ARCHITECT'S FIELD REPORT

PROJECT	Ohio City Town Hall Interior and Exterior Rehabilitation, Phase II SHF Project # 2017-01-021	DATE	9/13/2017
----------------	---	-------------	-----------

WORK OBSERVED	
Window & Door Installation and Paint Colors	
TRADES PRESENT	
None

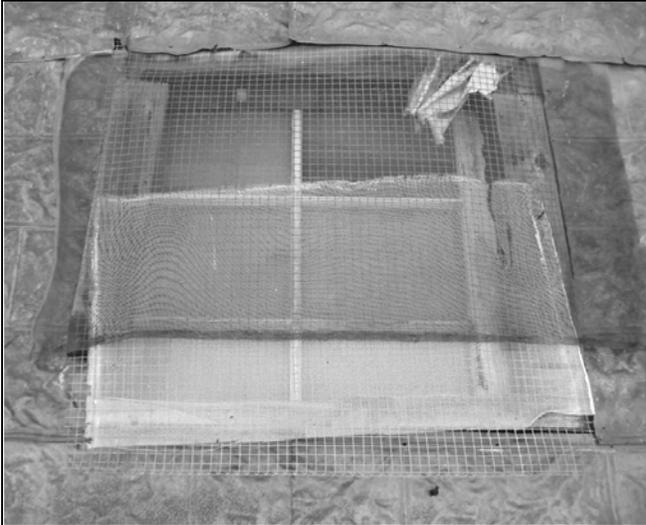
PHOTO – WORK ITEM	DESCRIPTION	ACTION
	<p>9/9/17 – Mock-Up Photo 1</p> <p>Photo rendering shows the storefront windows painted in the same color as the existing interior trim, color match SW 6233 “Samovar Silver.”</p> <p><i>While the storefront windows may have been painted at one time, the paint finish was deemed inappropriate as it does not match the current historic character.</i></p>	<p>Note</p>
	<p>9/9/17 – Mock-Up Photo 2</p> <p>Photo rendering shows the storefront windows painted in the same color as the existing interior side door, color match SW 6013 “Bitter Chocolate.”</p> <p><i>Again, this was not the recommended finish due to the effects on the historic character of the building.</i></p>	<p>Note</p>
	<p>9/9/17 – Mock-Up Photo 3</p> <p>Photo rendering shows the storefront windows treated with an exterior wood preservative. The coloration of the wood is slightly darker.</p> <p><i>It was determined that this was the appropriate exterior finish for both preservation and long term maintenance.</i></p>	<p>Note</p>

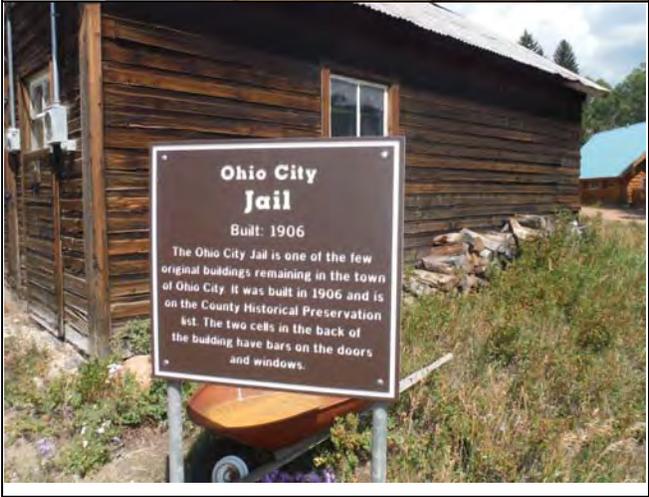
PHOTO – WORK ITEM	DESCRIPTION	ACTION
	<p>9/9/17 – Photo 4</p> <p>Detail of the side window muntins.</p> <p><i>Review of the muntin width by the SHF is requested.</i></p>	<p>Note</p>
	<p>9/9/17 – Photo 5</p> <p>Side window as seen from the interior. The awning crank is visible on the right jamb. A cover over the crank has not been installed.</p> <p>Interior trim has been set.</p> <p>Interior finish has not been determined.</p>	<p>Note</p>
	<p>9/9/17 – Photo 6</p> <p>Detail of the window muntin on the installed window. The width is 7/8".</p> <p><i>Review of the muntin width by the SHF is requested.</i></p> <p>Interior finish has not been determined.</p>	<p>Note</p>
